Amendments/Additional Information

FW: NYM/2016/0753/FL

North York Moors National Park Authority

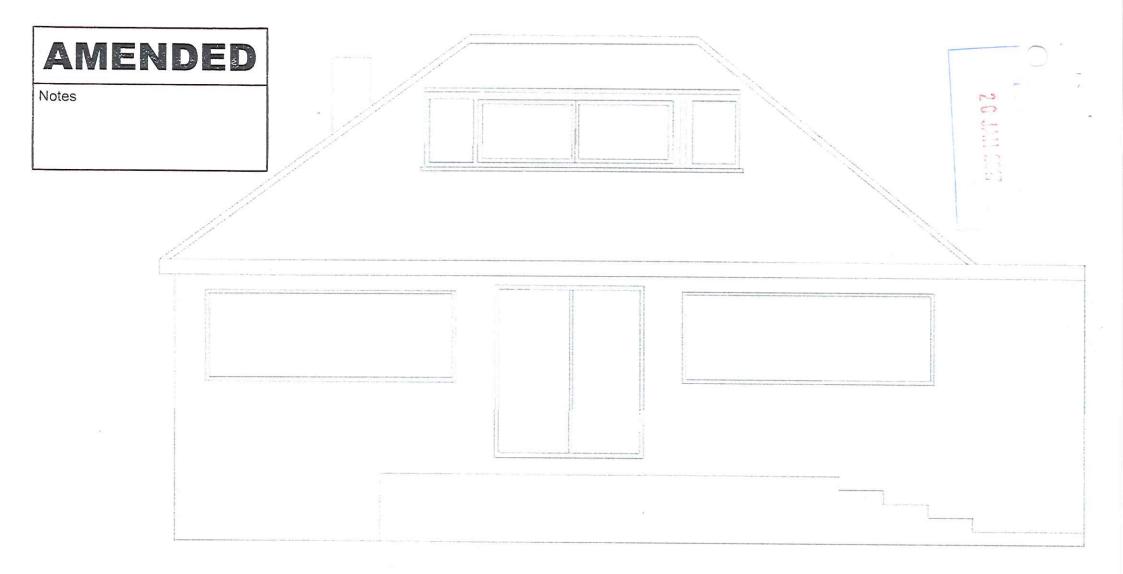
Amended layout of buildings/outside areas
	Additional background information
V	Amended design - changes to dormer have been reduced in scale
	Revised access arrangements
	Change of description of proposed development
	Change in site boundaries
	Other (as specified below)

Just one small point - our intention is to have the window in three sections, not four ie with a larger middle section and smaller ones at the side. Should I get the 'East proposed' redrafted?

Thank you for your e-mail and attached plans, received Monday (23 January). As promised, I have been working on your application this afternoon and I thank you for the substantially reduced scheme. I am of the opinion that the revised plans are a significant improvement which satisfactorily address my original concerns (but I will still need to re-consult the Parish Council in view of their initial objection). However, it seems through the scan/email process the scale has been distorted and I cannot update the file with these plans. I have compared both sets of 'existing' drawings; the dormer measures approximately 4 metres wide on the original plans but only 3 metres wide on the plans submitted yesterday. I have checked several other dimensions but the new plans are measuring up much smaller in all areas. I am told that this is a regular problem with plans submitted as a 'jpeg' but 'PDF' attachments are usually OK. Consequently, would you be able to resubmit the drawings as PDF attachments or send paper copies in the post?
